Preliminary Information

PIT5507C Service Park Assist Message At Start Up With DTC U0159 / False Alerts / Park Assist Off Message

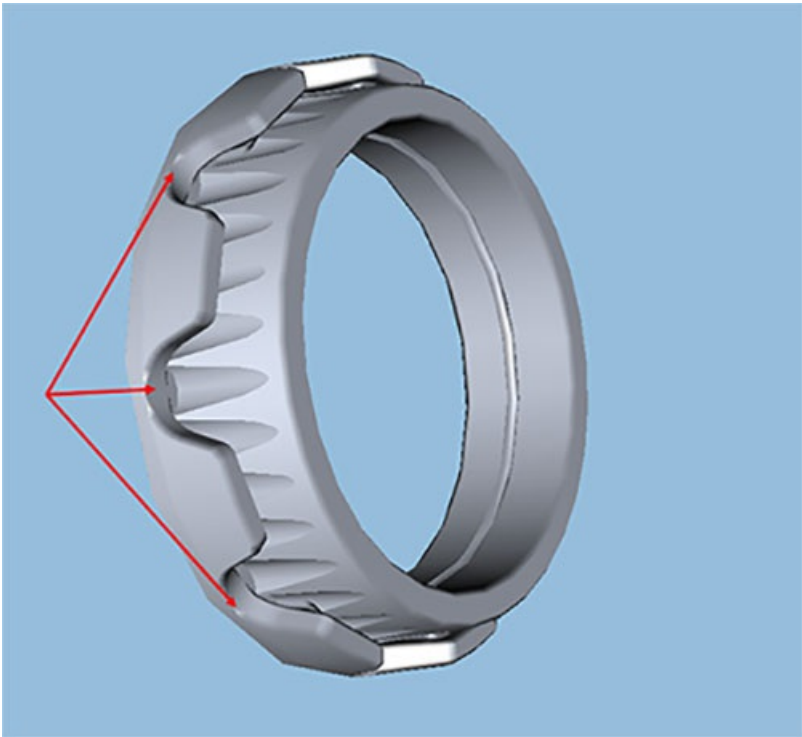
Condition 3 - The 2016-2017 Silverado 1500 and Sierra 1500 models use a new/different style front park assist sensor ring, which is scalloped, as shown below. There have been reports of replacement front park assist sensors coming with the incorrect sensor ring, which do NOT have the scallops. If the wrong sensors rings (withOUT the scallops) are installed, it will cause unwanted/false front park assist alerts. This can cause the system to display the "Park Assist Off" message.

Remove the front park assist sensor(s) and inspect the sensor rings for the scallops molded into the ring, as shown below. If there are no scallops molded into the ring, the wrong sensor ring(s) are installed. Replace the sensor ring(s) with GM part number 84075328, which is the new scalloped design.

It is imperative when installing the sensor rings to pay close attention that the sensor and ring are properly installed. If the sensor and ring are not properly installed and there is binding/misalignment/etc. of the sensor/ring, it will continue to cause unwanted/false alerts.
